SUNDRY NOTICES AND REPORTS ON WELLS (DO NOT USE THIS FORM FOR PROPOSALS TO DRILL OR TO DEEPEN OR PLUG BACK TO A DIFFERENT RESERVOIR. USE "APPLICATION FOR PERMIT" (FORM C-101) FOR SUCH PROPOSALS.) 1. Type of Well: Oil Well ☒ Gas Well ☐ Other ☐		WELL API NO. 30-025-22133
2. Name of Operator Lease Holders Acquisitions		5. Indicate Type of Lease STATE ☐ FEE ☐
3. Address of Operator 705 S Mustang rd #127, Yukon, OK 73099		6. State Oil & Gas Lease No.
4. Well Location Unit Letter <u>G</u> 1980 feet from the <u>N</u> line and <u>2005</u> feet from the <u>E</u> line Section <u>10</u> Township <u>11S</u> Range <u>33E</u> NMPM County Chaves		7. Lease Name or Unit Agreement Name JP Collier
11. Elevation (Show whether DR, RKB, RT, GR, etc.)		8. Well Number 004Y
9. OGRID Number 372076		10. Pool name or Wildcat BAGLEY;PERMO PENN, NORTH

Plug And Abandonment Procedure

JP Collier #004Y

Lea County, NM / API 30-025-22133

Proposed Wellbore Diagram

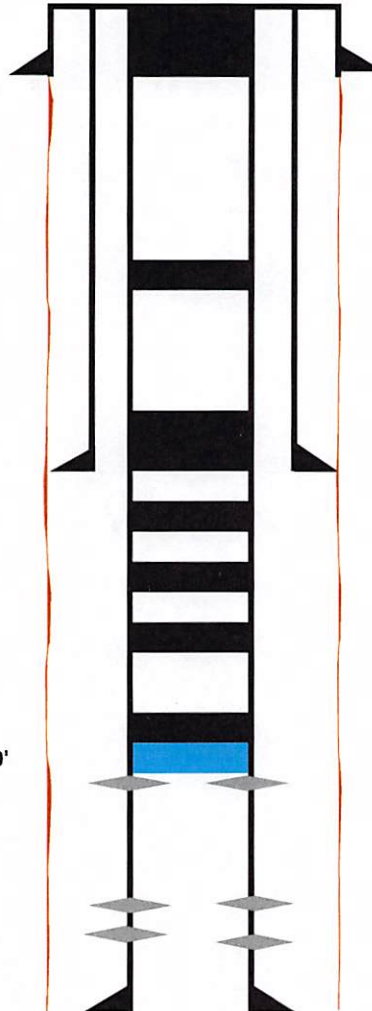
Add a plug that covers 9903-9276 for the Ranger Lake and the Mid Penn.
